SUBJECT: EVALUATION OF THE HOMESTAKE MINING COMPANY REQUEST TO REVISE
THE SOIL CLEANUP VERIFICATION PROCEDURE

TECHNICAL EVALUATION OF THE HOMESTAKE MINING COMPANY
AMENDMENT REQUEST TO REVISE THE SOIL CLEANUP VERIFICATION PROCEDURE

DOCKET NO. 40-8903

FACILITY: Homestake (Grants Uranium Mill)

SOIL CLEANUP VERIFICATION
 SURVEY PLAN

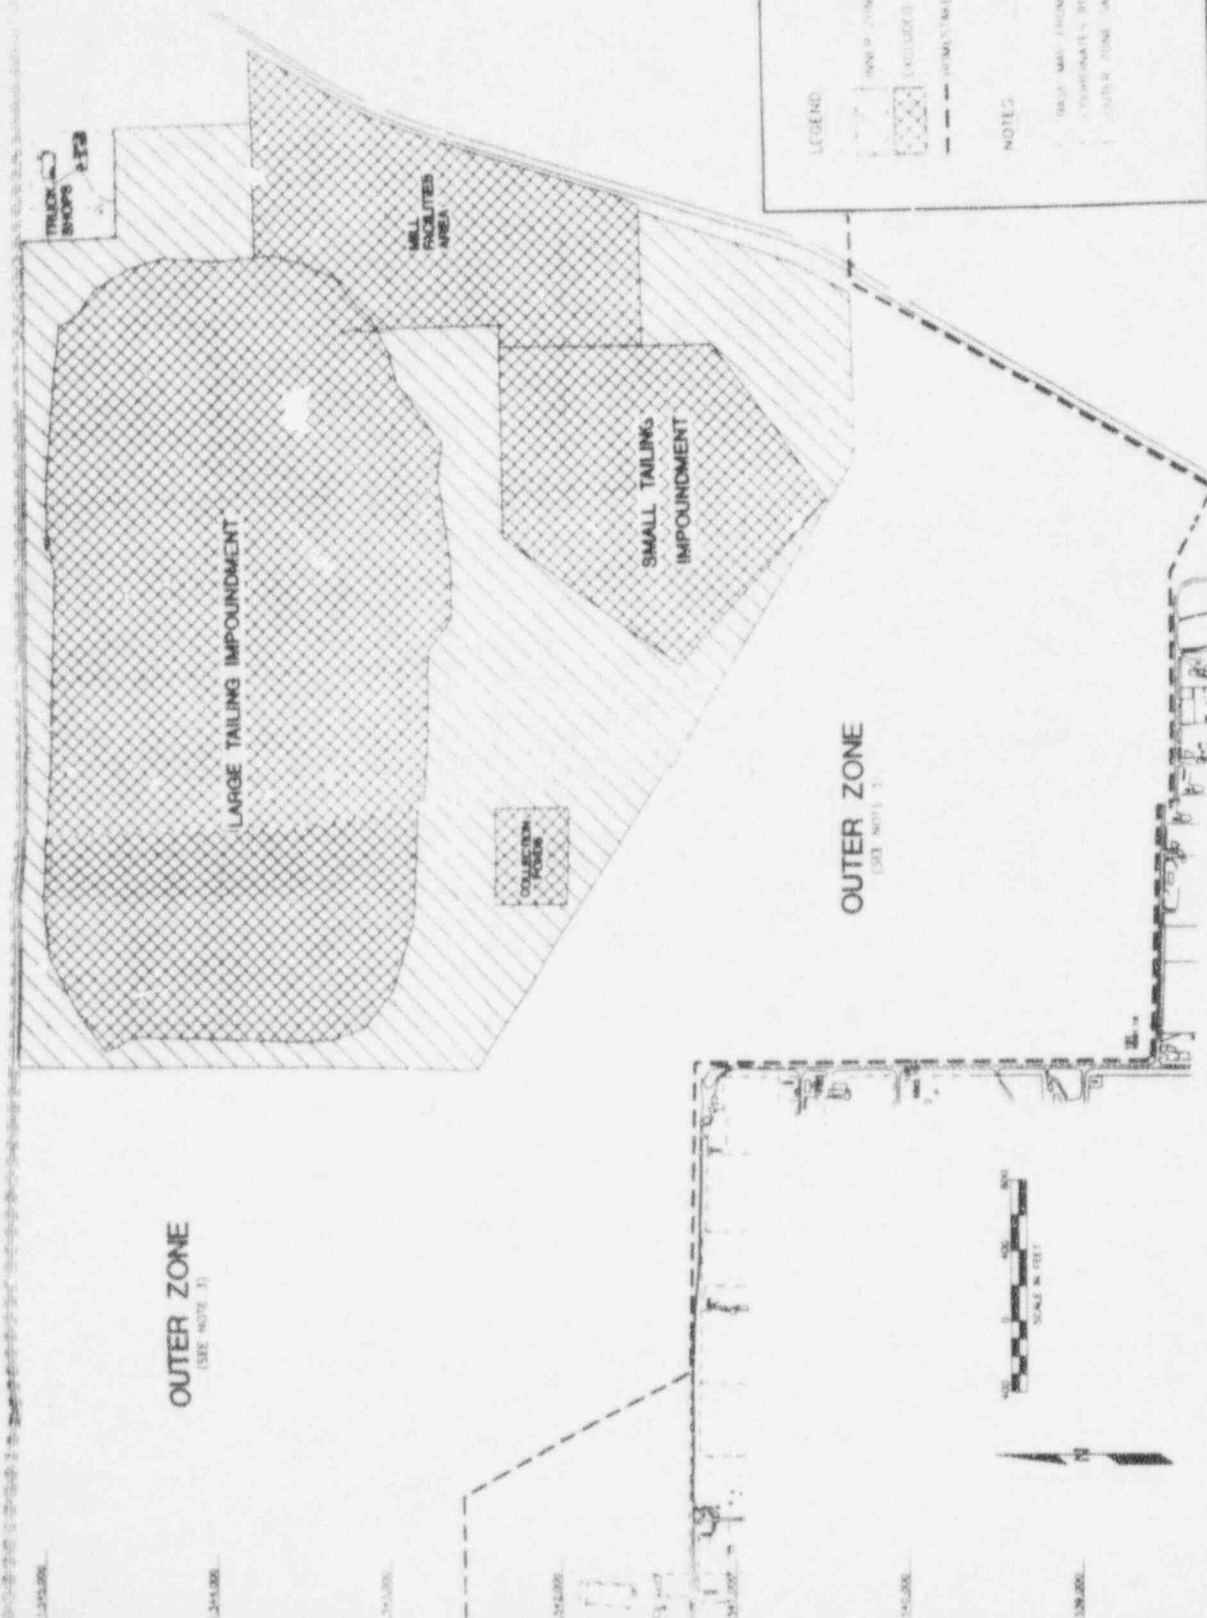
- 1) collect five soil samples to composite from the 100 m² area with the highest gamma values in every 152 by 152-meter (500 by 500-foot) area of the inner zone (see Attachment A), and document a minimum of 7 gamma measurements for each 100 m² area;
- 2) collect five soil samples to composite from the 100 m² area with the highest gamma values in every 305 by 305-meter (1000 by 1000-foot) area in the outer zone, except for 50 blocks next to the inner zone, and document a minimum of 5 gamma measurements for each 100 m² area; and
- 3) demonstrate that the mean Ra-226 concentration of the sampled grids is 10.5 pCi/g or less at the 95 percent confidence level.

Homestake proposes to composite 5 soil samples from 100 m² areas (verification grids) to determine the Ra-226 concentration. This is a standard method and meets the regulation by providing an average value. Homestake's rationale for sampling fewer grids in the outer zone is that the contamination level is less, is all surficial, and is more uniform than the contamination in the inner zone. NRC staff determined that this sampling approach is acceptable.
